Quick connector CK

Engineering Change Notification

ECN No.
279494

Project Title
Change of Coating

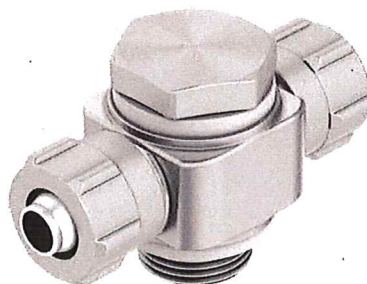
All blue anodized aluminium parts are changed to clear/colorless anodization with no change in layer thickness.

Previous Version

With blue anodization

Future Version

With clear anodization
